**Re: *Second Engineering Review  
Earth Removal Application  
182 Plympton Street  
ADE Project #2518.31***

**Re: *Initial Engineering Review  
Earth Removal Application  
182 Plympton Street  
ADE Project #2518.31***

**Subject: RM Thomas Excavating- 182 Plympton Street-Earth Removal Permit Review**

*Re: Earth Removal Application, 182 Plympton Street, Middleborough, MA*

**DETAIL SHEET FOR CRANBERRY BOGS**  
182 PLYMPTON STREET  
MIDDLEBOROUGH, MASSACHUSETTS

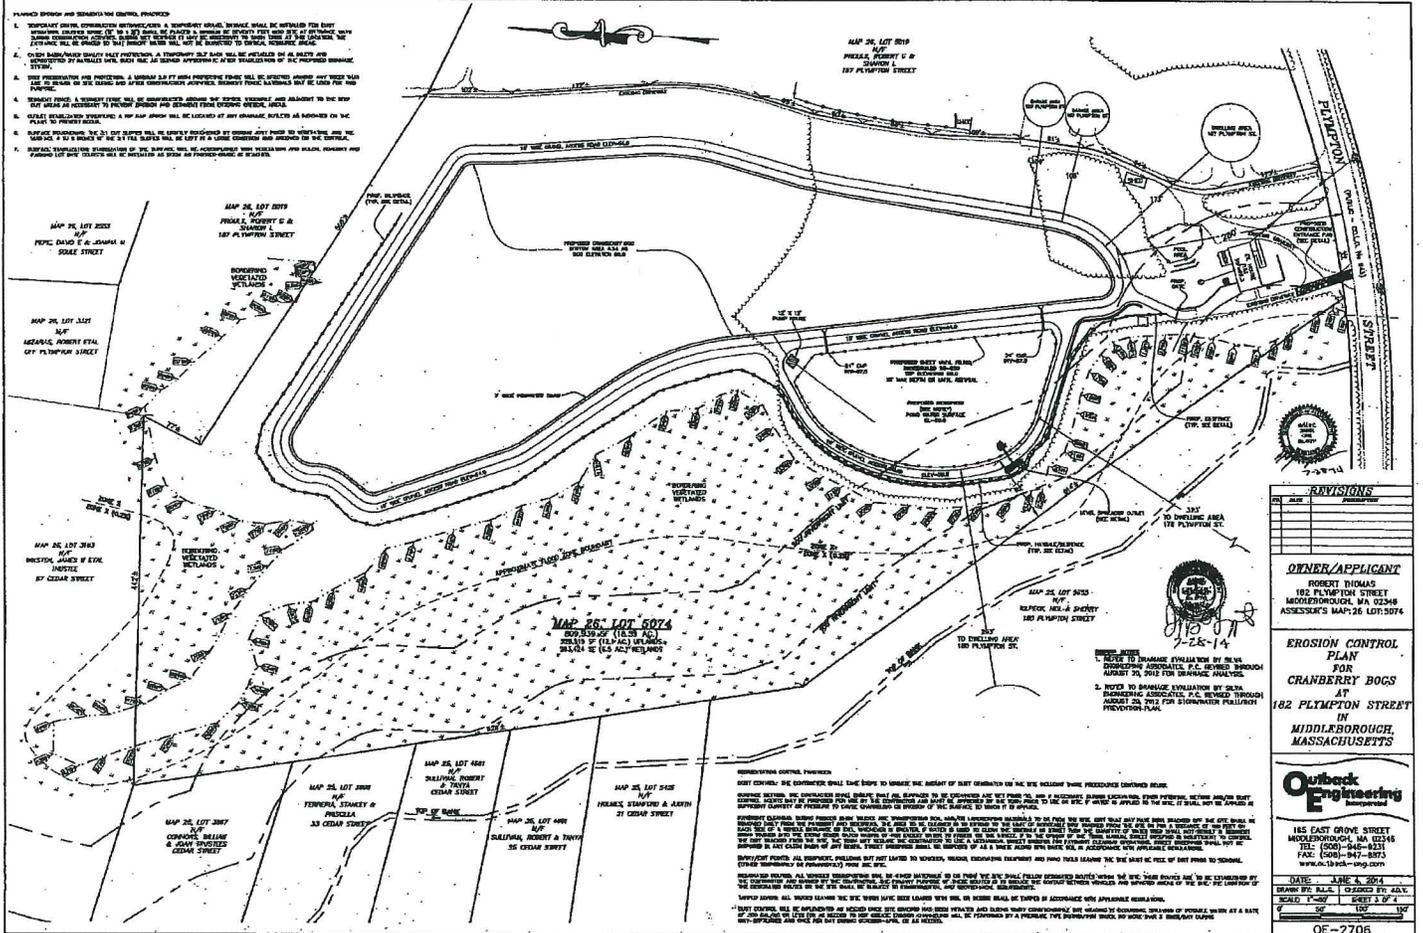
- 11. The erosion control blanket detail should specify for use on all slopes steeper than 3:1.
- 12. No further comment
- 13. Provide more detail of the level spreader outlet. (Rip-rap size, length, width, depth, elevations, etc.). The concern is that there is insufficient room to construct everything outside at the 25-foot no work zone.

11. The erosion control blanket detail should specify for use on all slopes steeper than 3:1.
12. Provide a detail for the sheet vinyl piling and clarify its purpose.

- B.12 A construction dewatering sump pit detail has been provided on Sheet 2 of the plan set. Dewatering shall be performed away from all resource areas.

5. A construction dewatering sump pit detail and notes have been provided on Sheet 2 of the plan set. Dewatering shall be performed away from all wetland resource areas.

15. The proposed slopes have been labeled accordingly on the plan.
16. A geotextile erosion control blanket detail has been provided on Sheet 2 for slopes greater than 3:1.

20. The grading was adjusted to eliminate the need for the retaining wall. The proposed bog was re-configured accordingly.
21. A level spreader detail has been provided on Sheet 2.

22. A hay bale/silt fence detail and a silt fence detail have been provided on Sheet 2.
23. – 29. Although SEA had submitted drainage calculations as part of their original ERA in 2012, a drainage report and compliance with DEP Stormwater

# SG-650

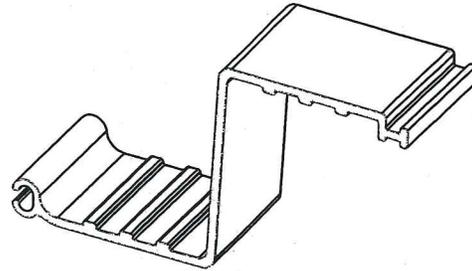
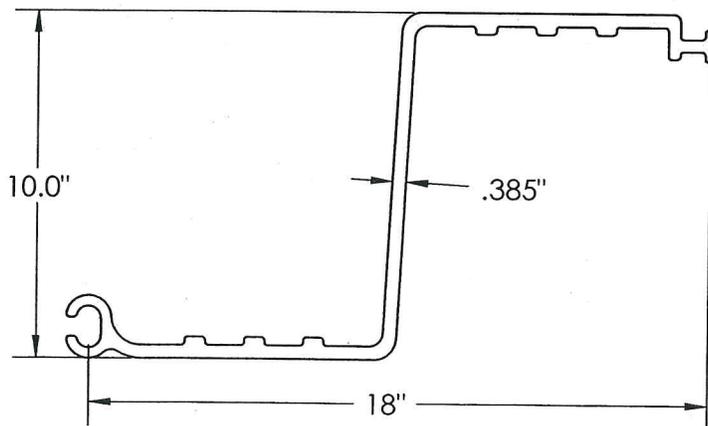
17. Provide a detail for the sheet vinyl piling and clarify its purpose.
18. The grading (56 contour) near wetland flag 38WH appears to show grading within the 25 foot no work zone.

17. Please see attached detail for Shore Guard (SG-650), which is a vinyl piling used for shore protection to prevent erosion of the interior reservoir bank.
